**SUBJECT: NEW VEHICLE DEMONSTRATION / DELIVERY HOLD -
 Safety Recall 22S09**

Certain 2017 - 2022 Model Year F-250/F-350 Vehicles Equipped with a 6.2L/7.3L Gas Engine, Crew Cab/Super Cab, 160"/164" Wheelbase, 4x4, and One-Piece Aluminum Driveshaft
 Loose/Sagging Underbody Insulator

SERVICE PROCEDURE

FIGURE 3

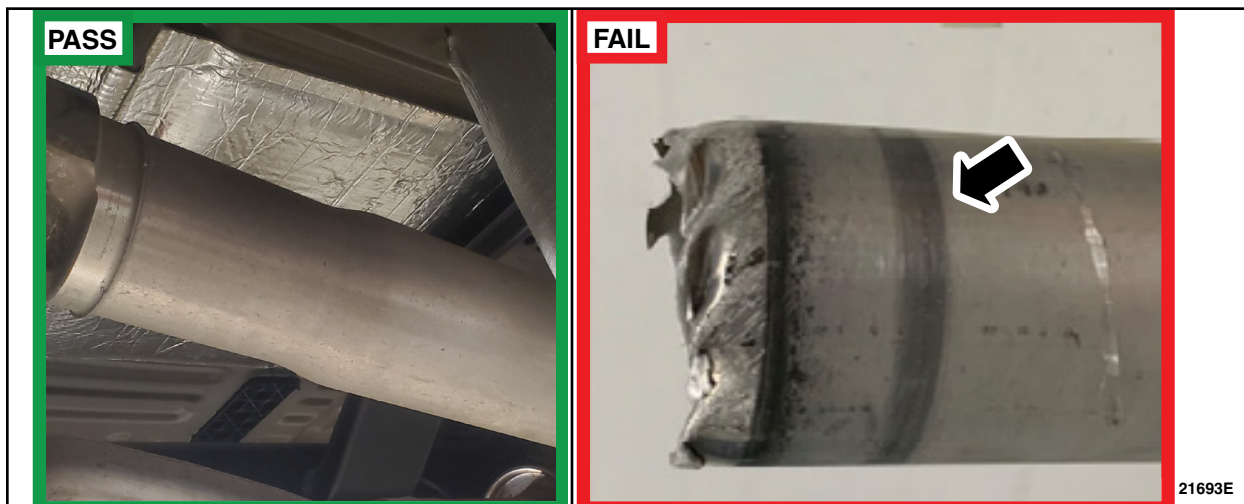
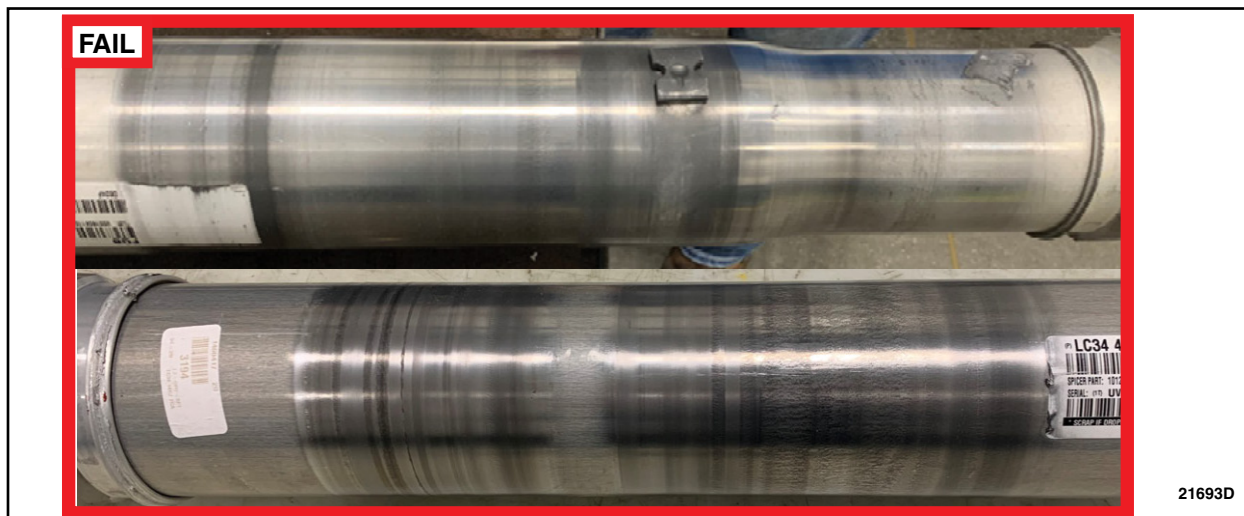
1. With the vehicle in NEUTRAL, position it on a hoist. Please follow Workshop Manual (WSM) procedures in Section 100-02.
2. Inspect the rear driveshaft for any marks caused by the passenger side insulator. Are there any marks present on the driveshaft due to contact from the insulator? See Figures 3 and 4.

Yes – Does not pass inspection. Contact the SSSC and provide a picture of the driveshaft with the marks. Once approved and replacement driveshaft is available, proceed to step 3.

No – Passes inspection. Proceed to step 4.

FIGURE 5

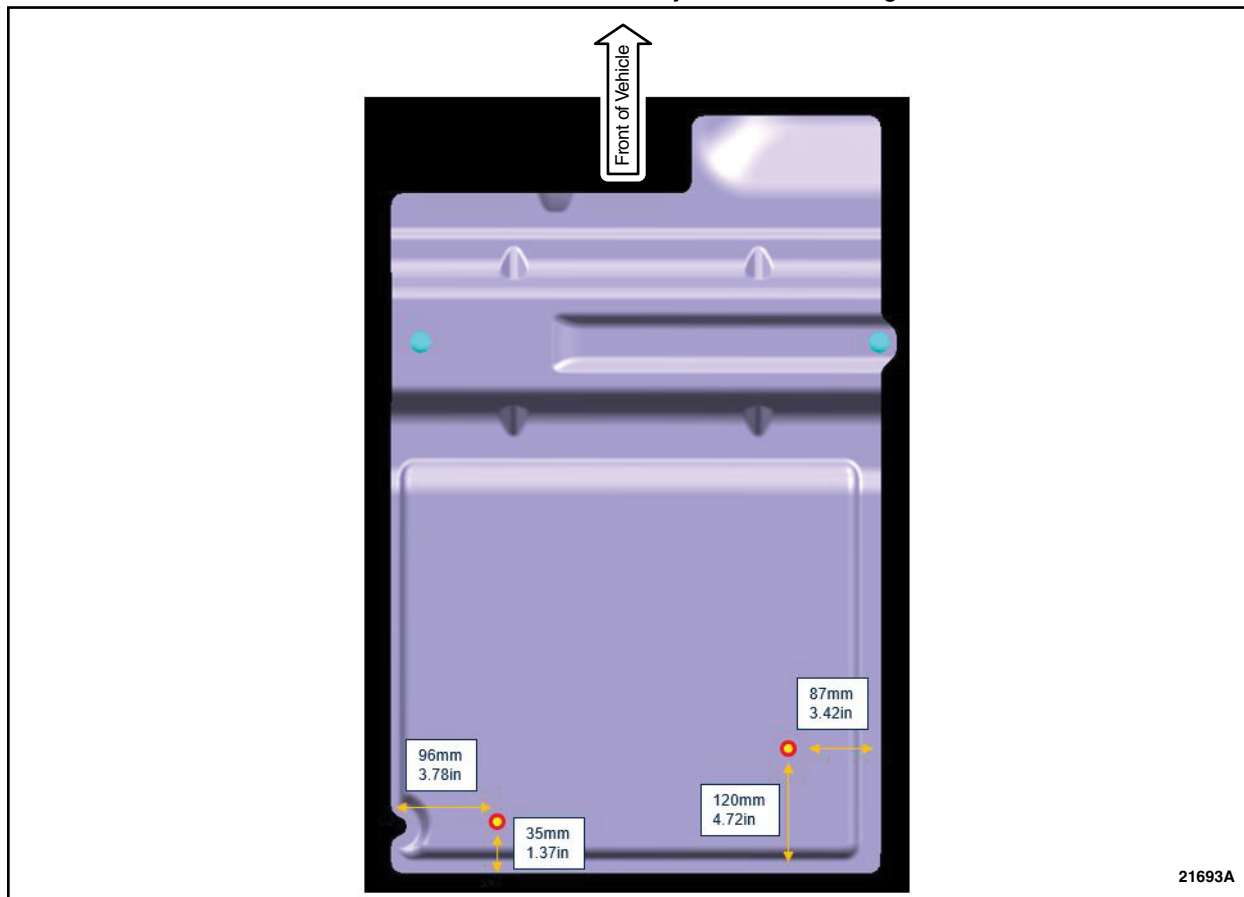
5. Measure and mark the two locations on the underbody insulator. See Figure 5.

FIGURE 6

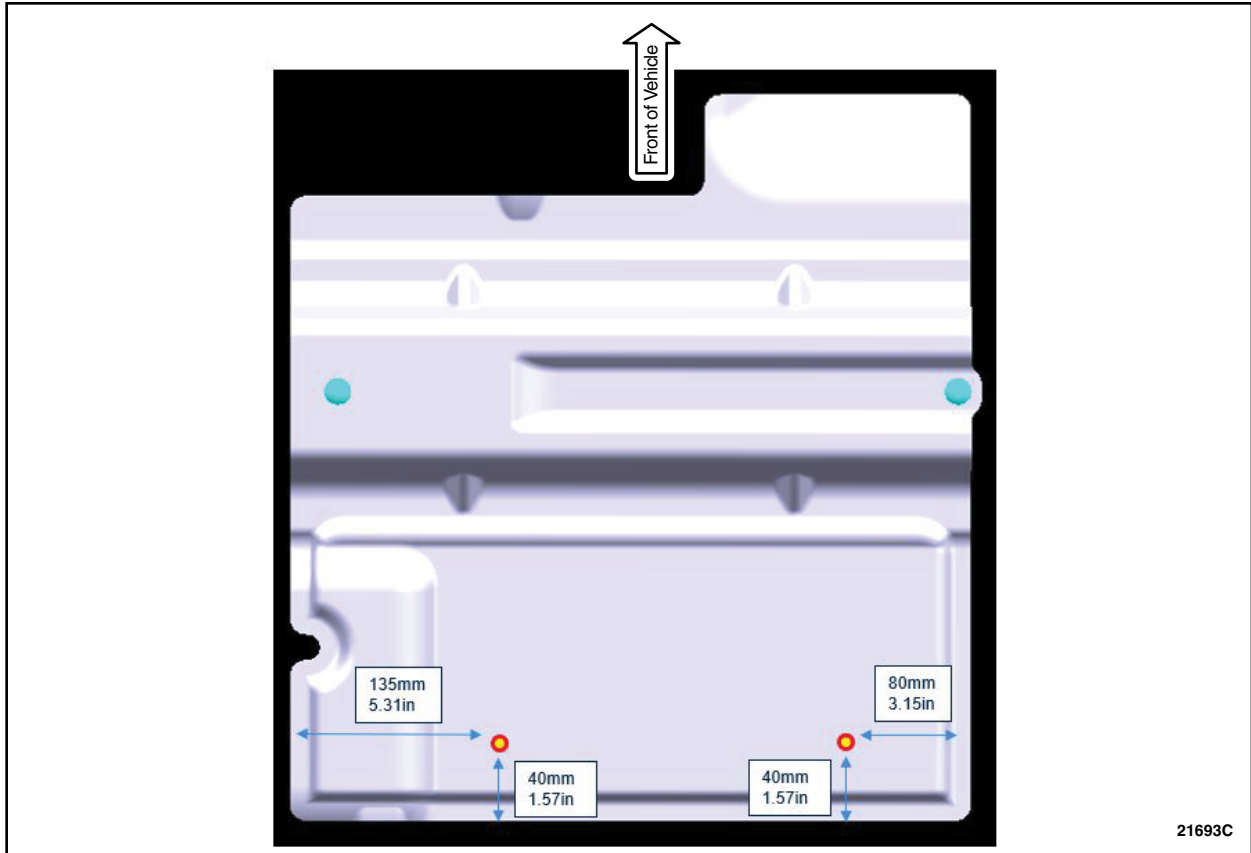
6. Measure and mark the two locations on the underbody insulator. See Figure 6.

FIGURE 7

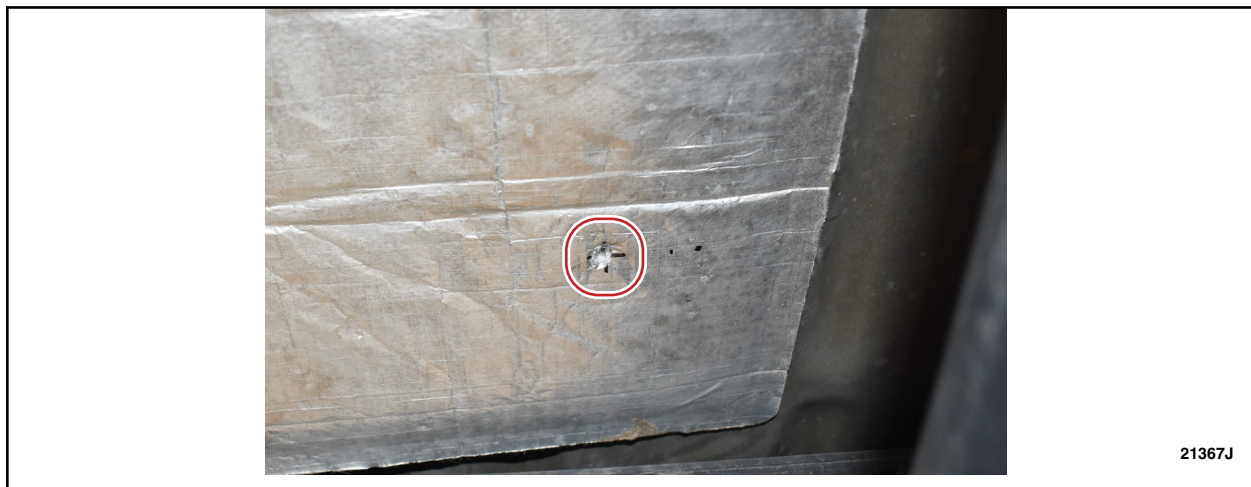
7. Using the 6.7mm (17/64 in) drill bit, drill a hole through the insulator and into the floor. See Figure 7.

NOTE: Use the 13mm (1/2 in) drill stop to ensure you do not drill through the carpet.

FIGURE 10

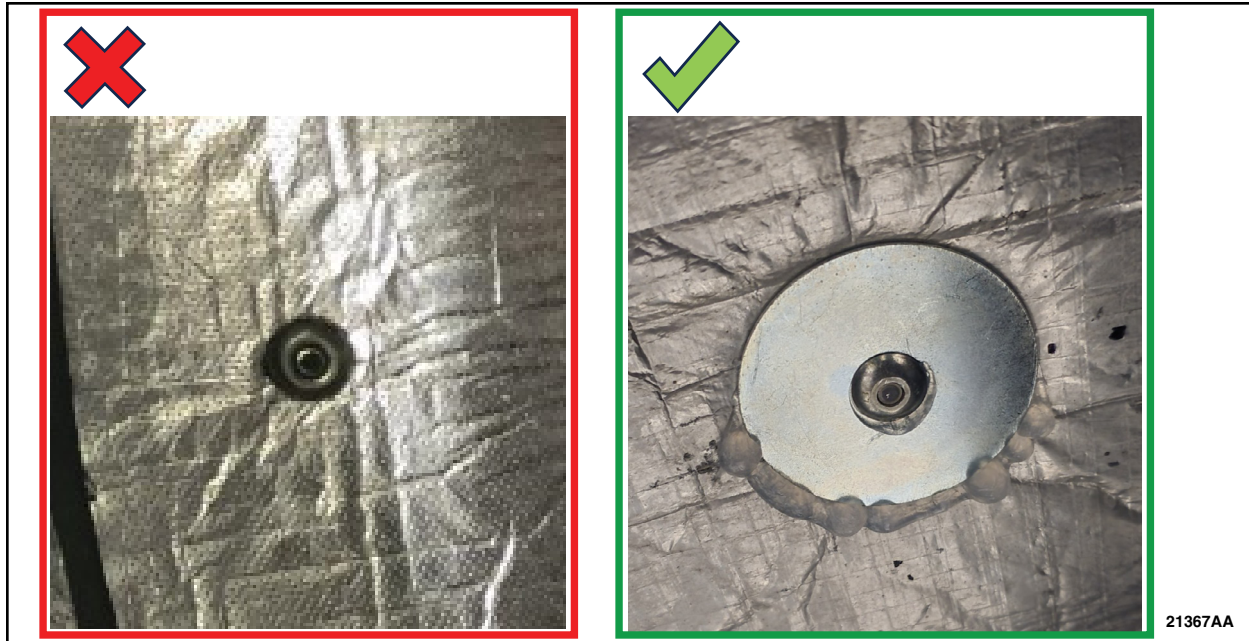
12. Using a 1/4" rivet gun, install the rivet and washer to the drilled hole. See Figure 10.

NOTE: To ensure the rivet is properly secured, apply as much force to the rivet gun as possible.

FIGURE 11

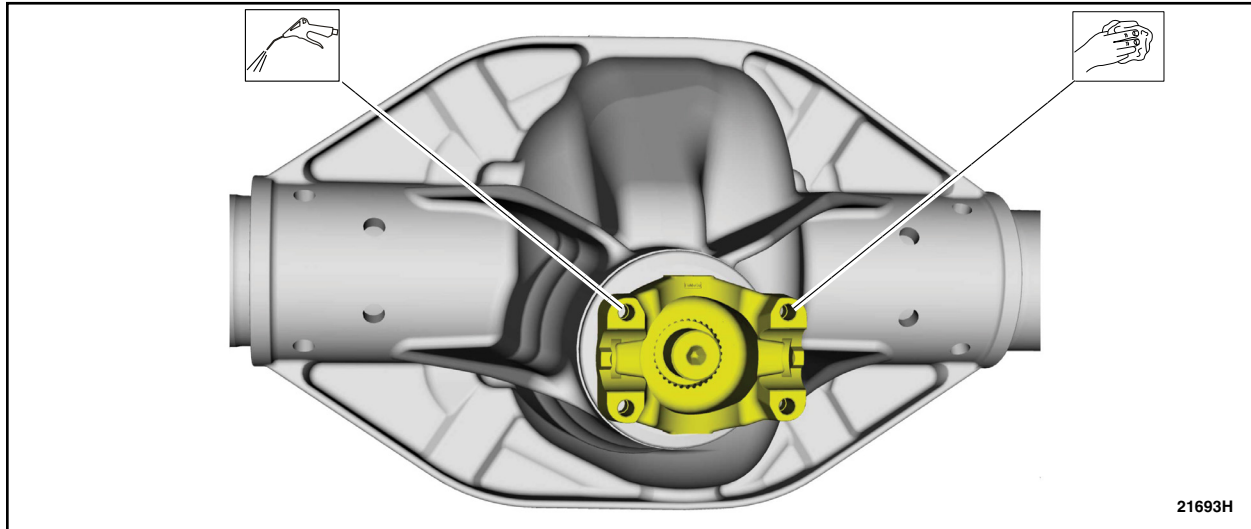
16. Using an air blow gun, remove any debris from threaded holes in axle flange. See Figure 11.

NOTE: Make sure that the mating faces are clean and free of foreign material.

FIGURE 12

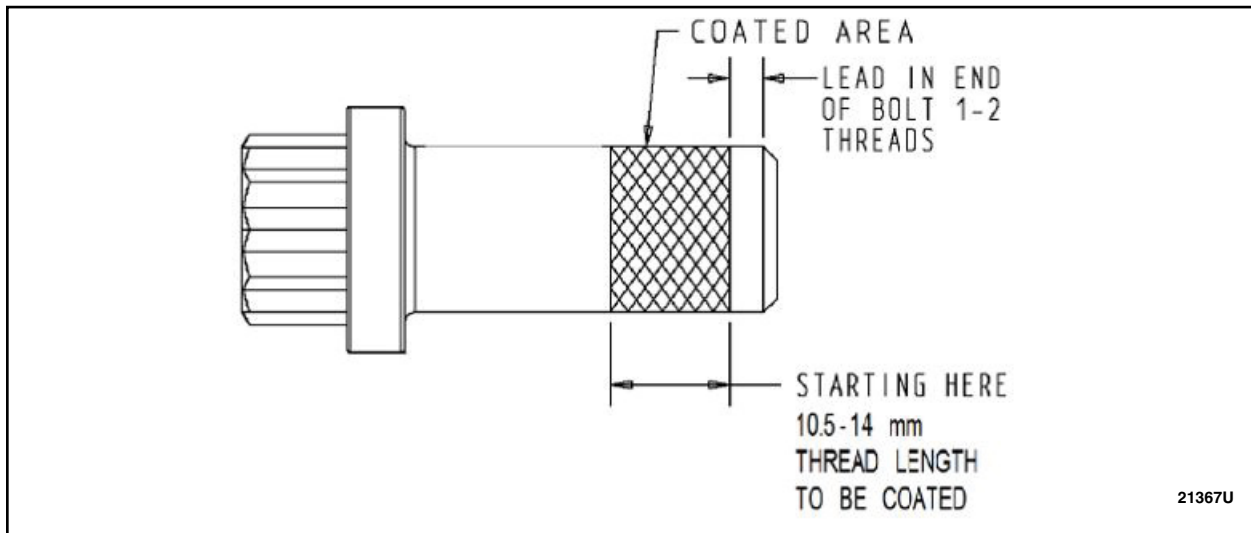
17. Inspect the original driveshaft flange to pinion flange bolts for rust in the threads and replace if rusted or damaged. Clean threads of the original driveshaft flange to pinion flange bolts with a wire brush and coat the threads with LOCTITE 243 Blue Medium Strength Threadlocker or equivalent. See Figure 12.
